Access Compliance Report

Public Rights-of-Way

(Pedestrian Signals)

Intersection ID: N/A	Main Street:	Cross Street: N/A	Location: N/A
ADA ID: 71581B965DFC	Signal Type: One Push Button-APS	Overall Compliance: No	Severity Score: BTN 1: N/A BTN 2: N/A No BTN: N/A
Codes/Mitigation Info/Possible Solution		Field Measurements/Component Compliance

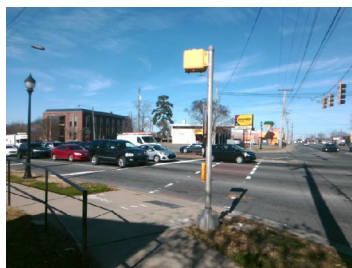
PROW/ADA: TMUTCD 4e.08, R404.2, R404.3, R406.2, R404.7.3, R209.1, MUTCD 4e.10

Possible Solutions: Replace Signal Push Button With APS Button on New Post. Remove & Relocate Sign.
